Subject: NHTSA Recalls and Technical updates- V85TT

Recall Communication:  USA market

- NHTSA RECALL 19V-857 Final drive oil leak ID # PGJZZQ1904
- NHTSA RECALL 19V-858 Footrest pin retaining clips ID # PGJZZQ1905
- Four possible additional Technical updates (VIN specific)

Affected Models: A select range of: **Moto Guzzi V85TT models**

PGJZZQ1904 “Installation of the Gearbox Cover” (The Final drive oil seal/cover)

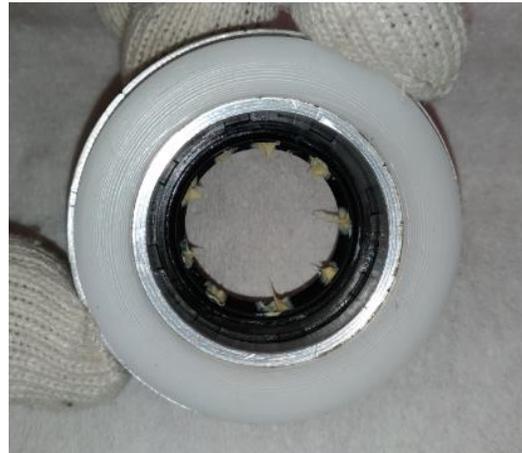
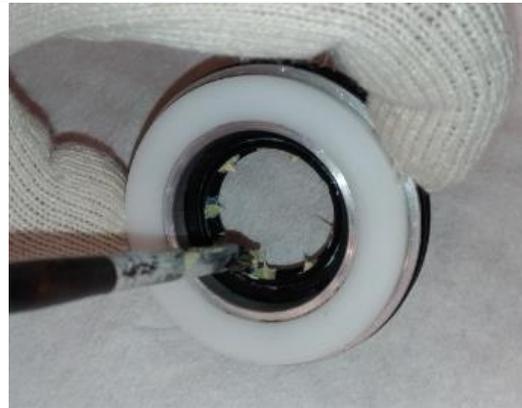
Clean only the surface of the wheel hub, on where the external O-Rings of the cover will ride, using a multi-purpose abrasive sponge cloth, see photo.

Using a small brush, apply mineral grease to fill the area between the 2 lips of the oil seal and the dust cover of the cover, respecting the method in the photo on the side.

The external o-rings must be lightly lubricated with the same grease; eliminate any surplus.

Fully insert the seal/cover on the spacer sleeve in the final drive, taking care to use the plastic tie included in the kit. This tie will allow air to escape, which will allow the complete insertion of the cover in its seat. Remove the plastic tie.

Important: to avoid damaging the oil seal lip, the tie must have the **smooth side** facing the sealing lip itself.

(2) PGJZZQ1902 "Check of sump cover and sump fixing"

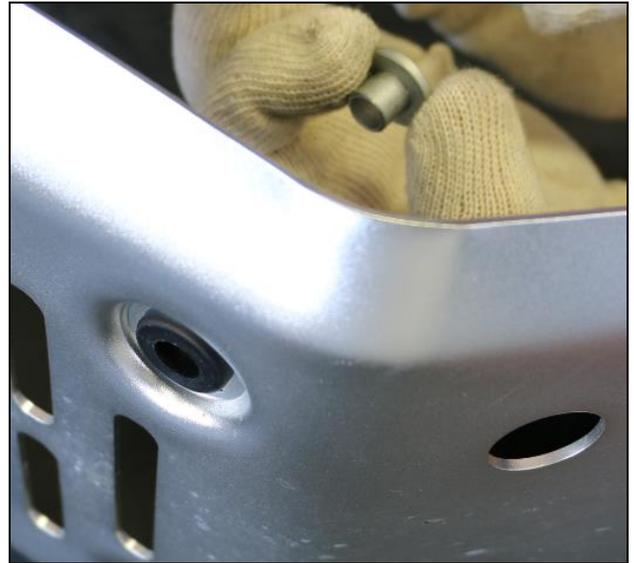
After removing the sump guard and the relative support brackets, update the tightening torque of the oil sump fixing screws (**oil pan bolts**) to **11-13 Nm or (8- 9.5 lb. ft.)**

(4) PGJZZQ1906 "Saddle lumbar cushion"

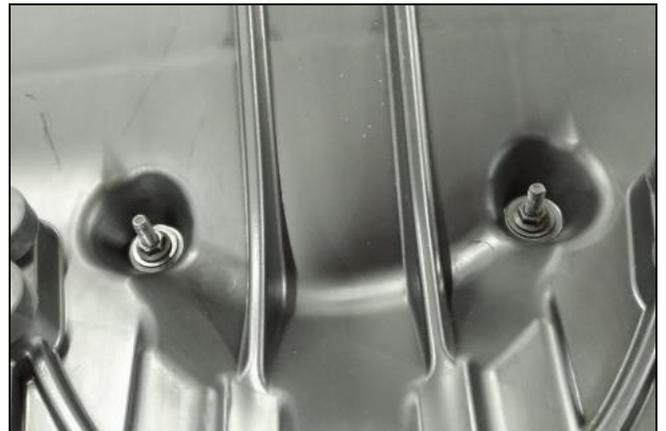
Select Coupon 1 to receive 2 self-locking nuts code AP8150114 (see photo on the right) which replace the previous ones and to receive the relative assembly labor. When fastening the new nuts, make sure that the cushion is close-fitting to the saddle. Parts are auto-shipped upon claim entry.

The washers below the nuts must be reused in the same position.

The nuts to be replaced are visible and accessible from the bottom of the seat (see photo to the side).

2.5 Nm or (1.8 lb. ft.)
